## ADDENDUM No. 1

PROJECT: University Medical Center  
CV/CICU Renovation &  
NICU Renovation  
602 Indiana Avenue  
Lubbock, Texas 79415

DATE: 05/12/2025  
PROJECT NO.: 22307 & 22419

1/P2 PARTIAL SIXTH FLOOR PLAN - SOUTH - PLUMBING

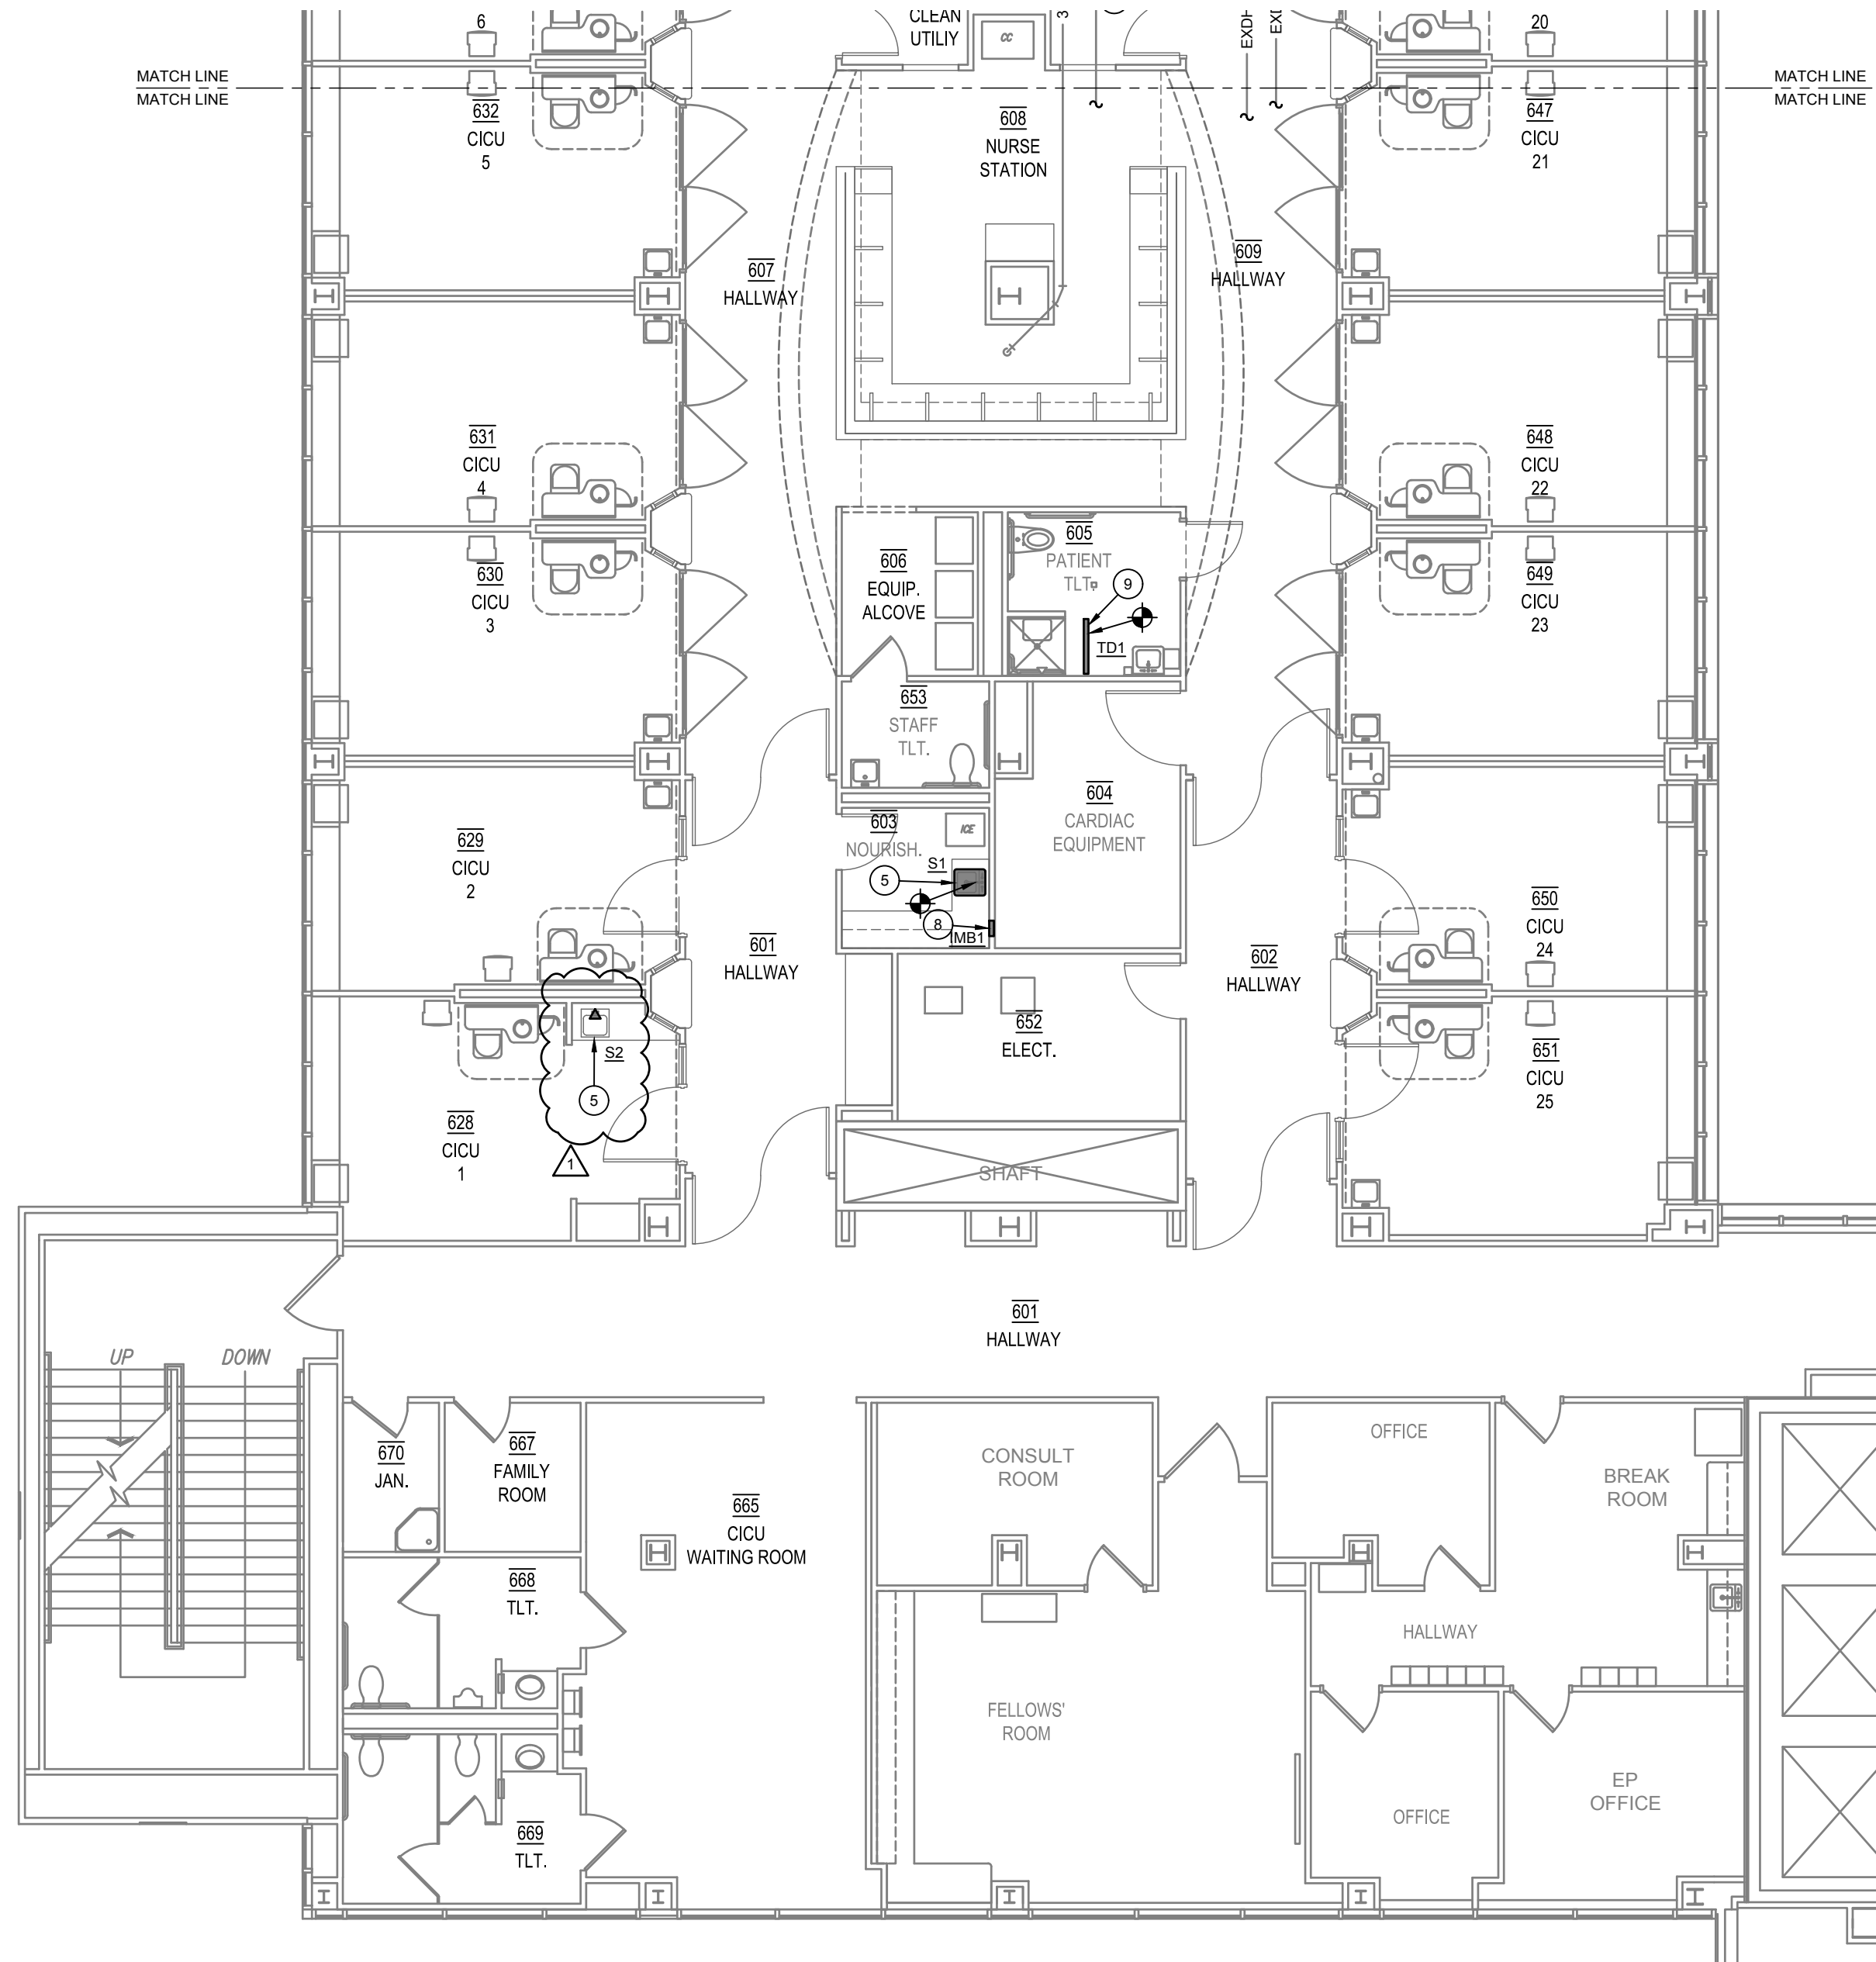
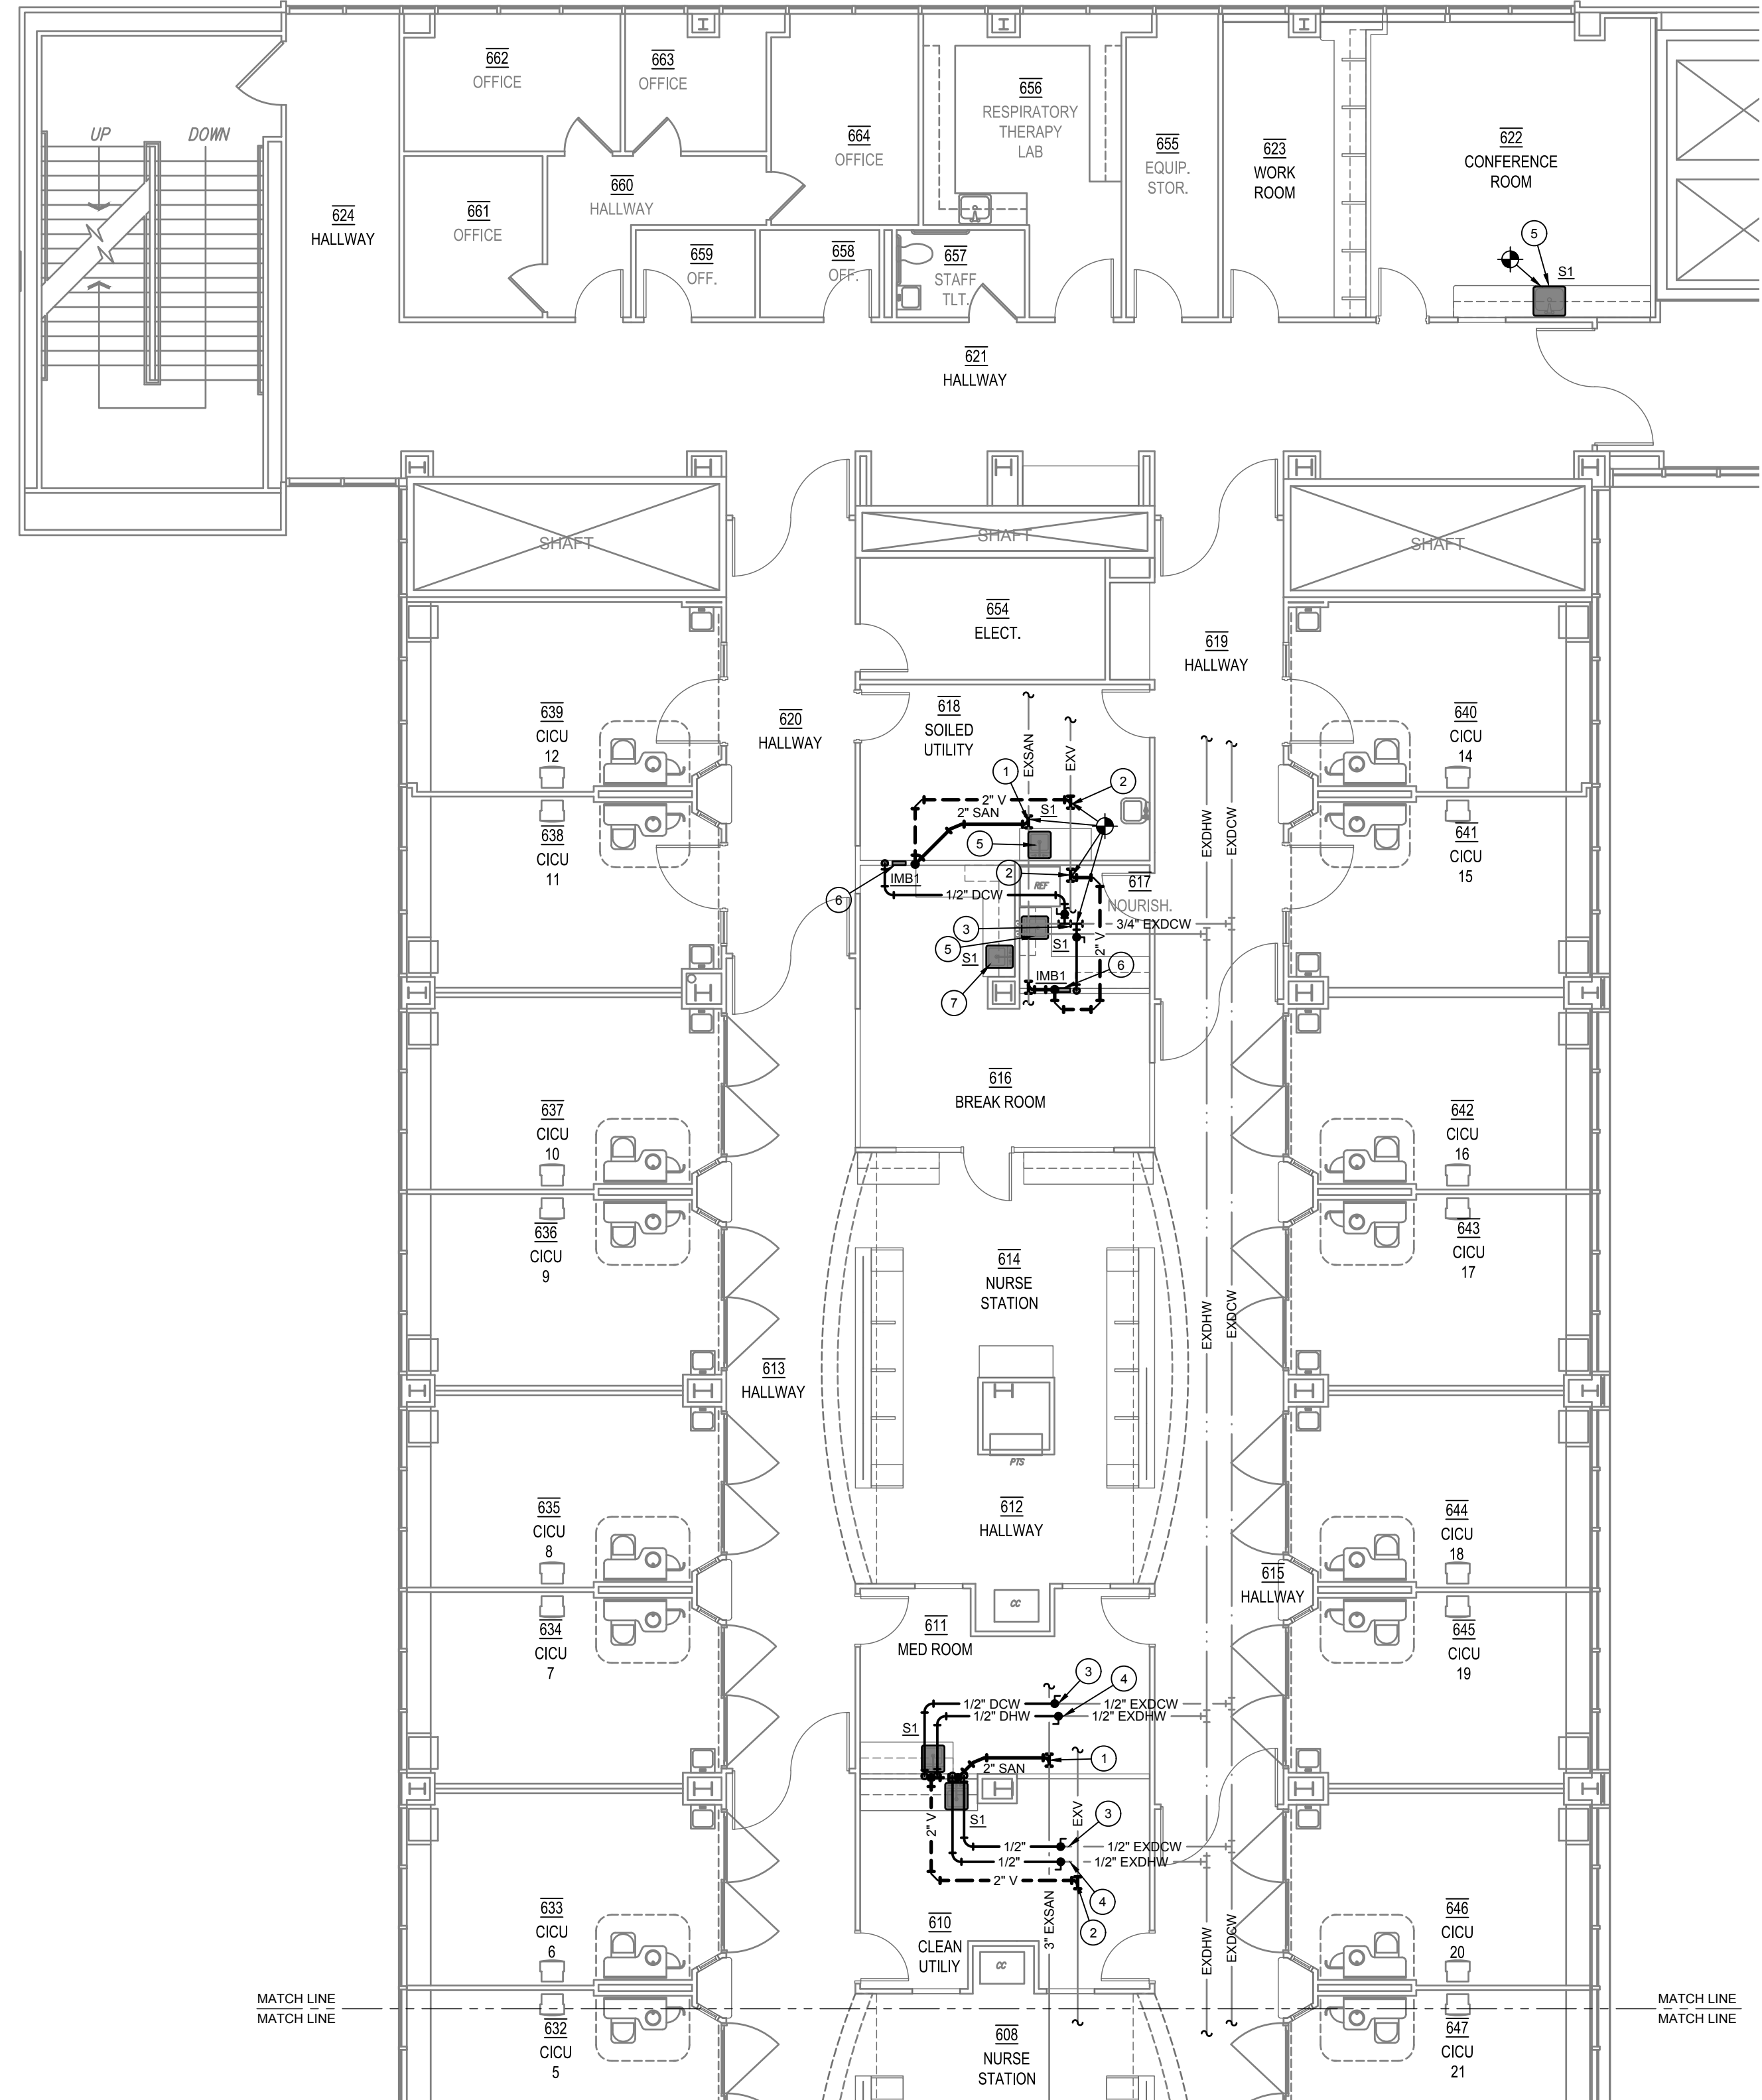
Item 2. Drawing Sheet P2:

- a. Provide new sink in CICU 1 Room as scheduled.

1/E1 SIXTH FLOOR PLAN - NORTH - ELECTRICAL DEMOLITION  
SCALE: 1/8" = 1'-0"

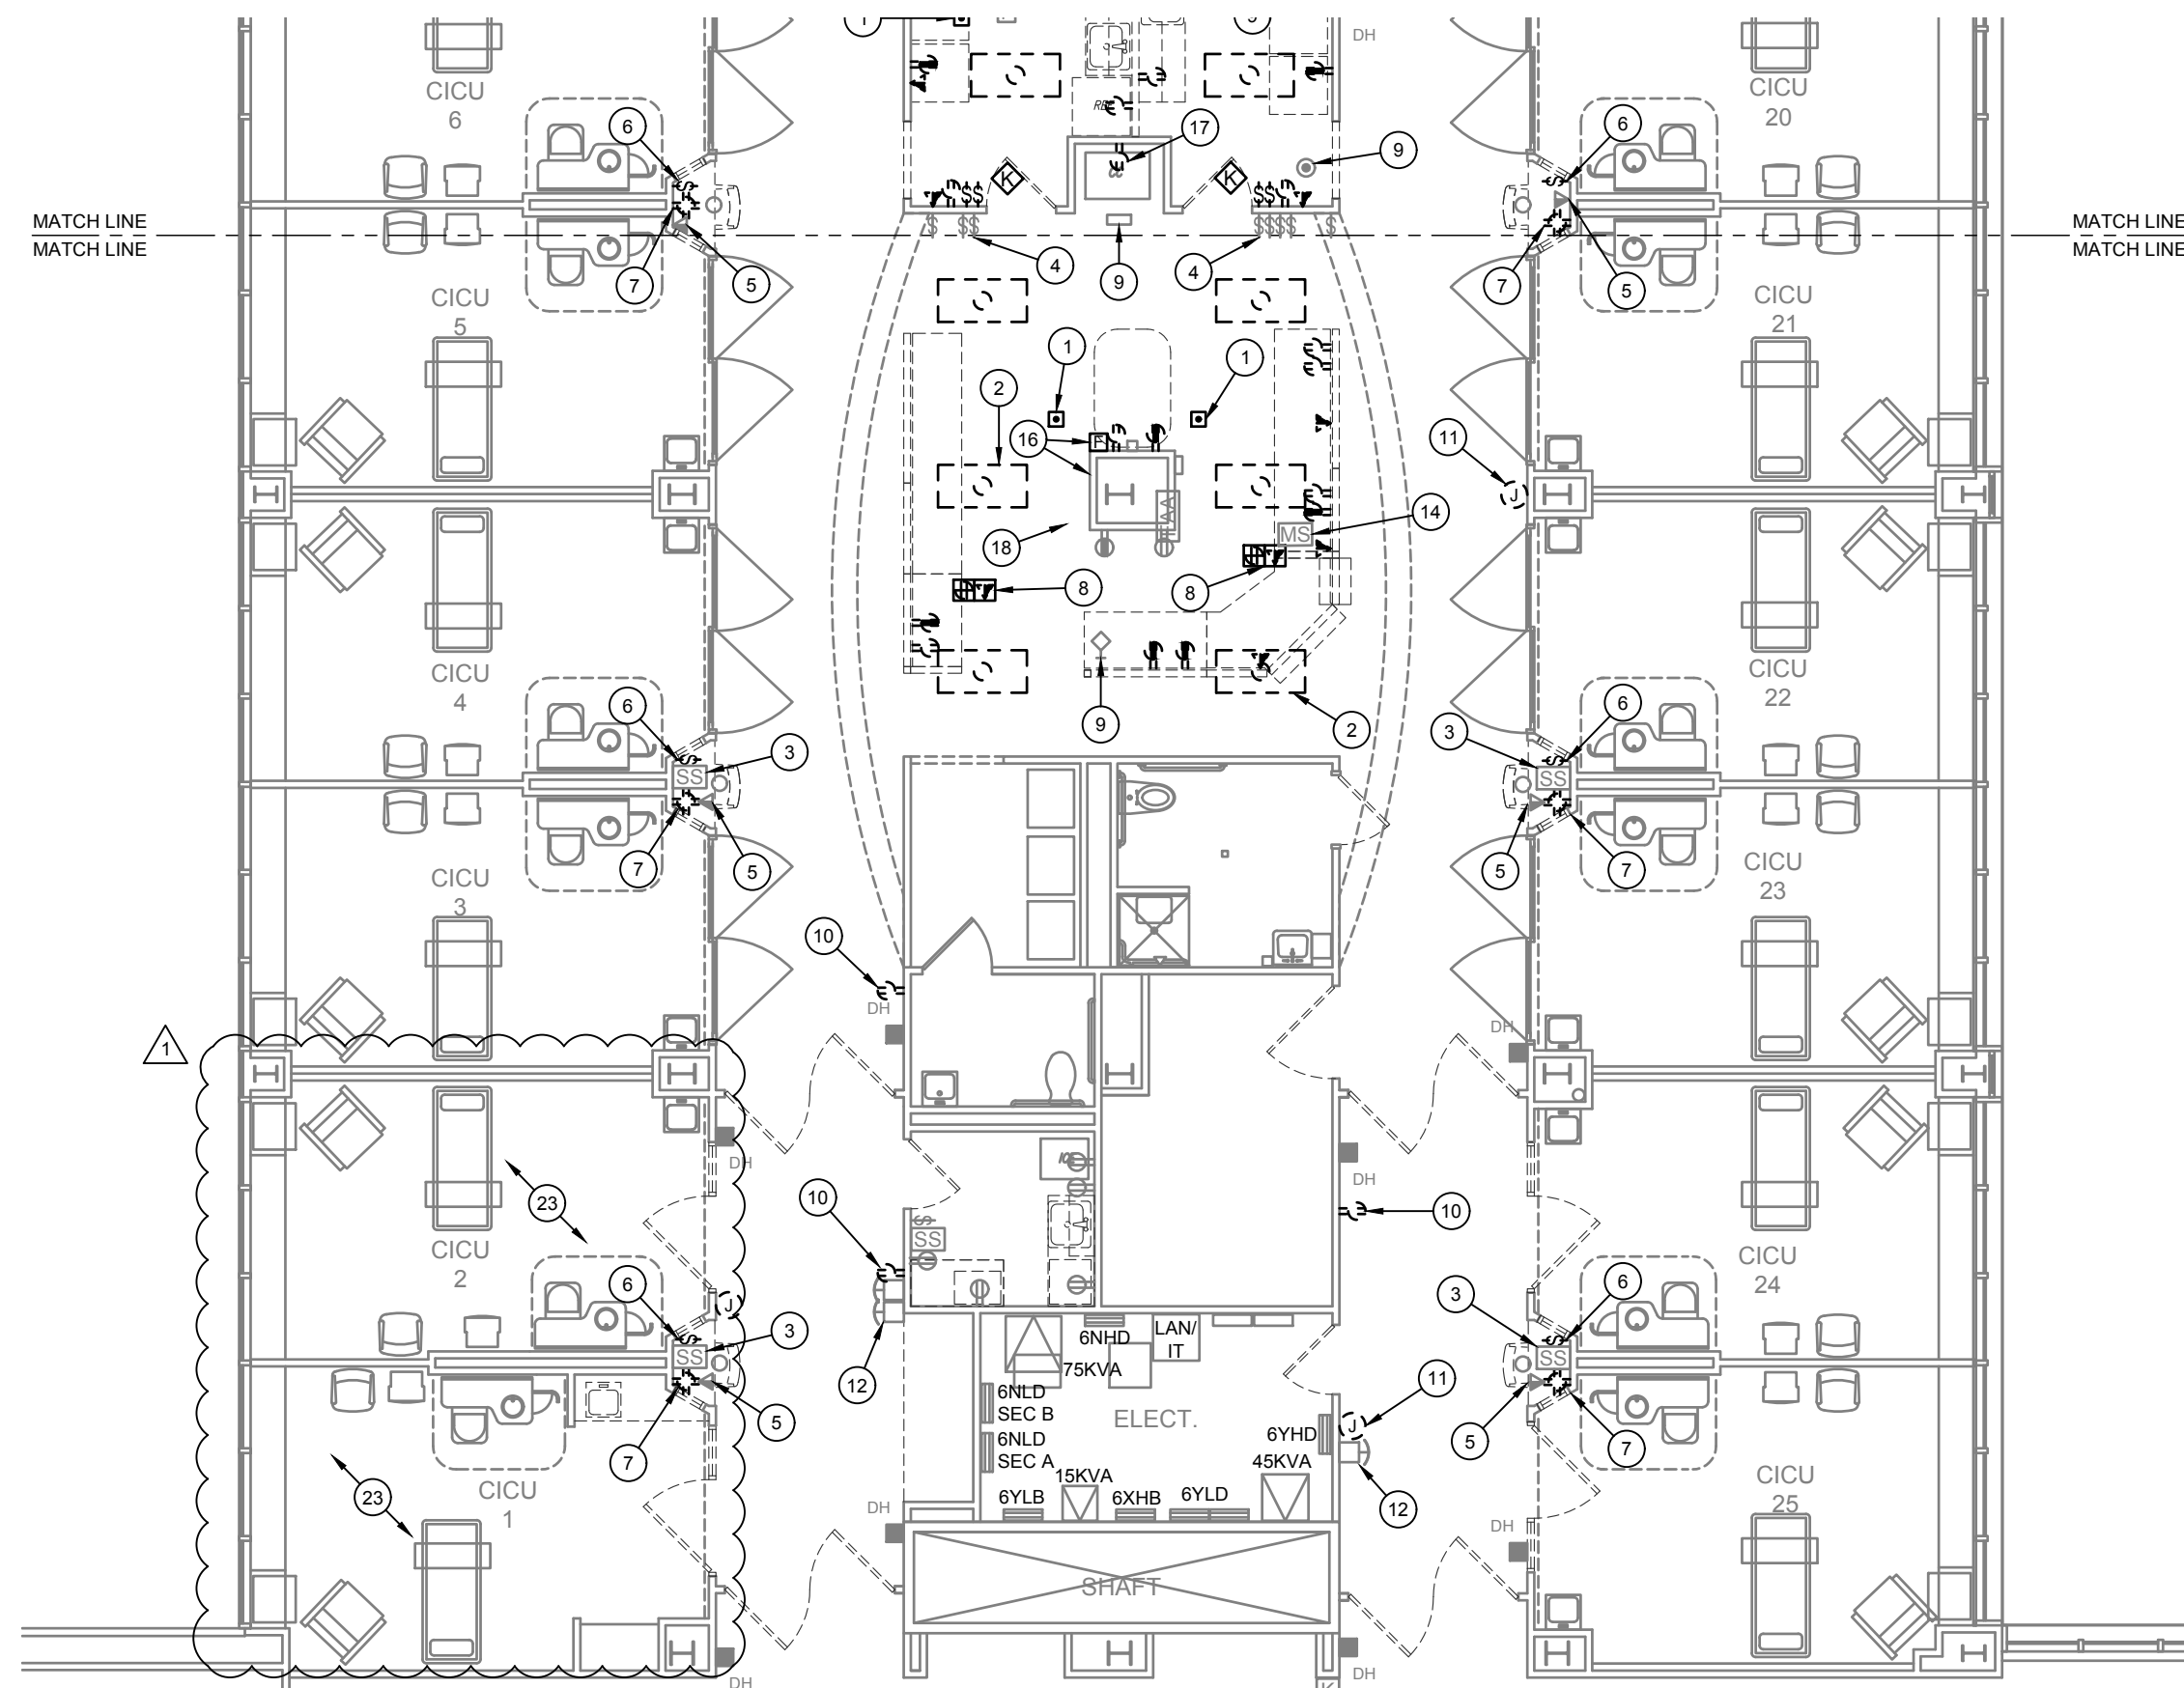
Item 1. Drawing Sheet E1:

- a. Added scope of work for alternate no.4 including light fixtures, switches and ceiling mounted devices in lobby area.
- b. Provide 120v circuit to serve new fire alarm equipment, power supplies, batteries, etc. Extend and connect to nearest 120v "life safety" emergency panel with available capacity. Coordinate location with fire alarm contractor.
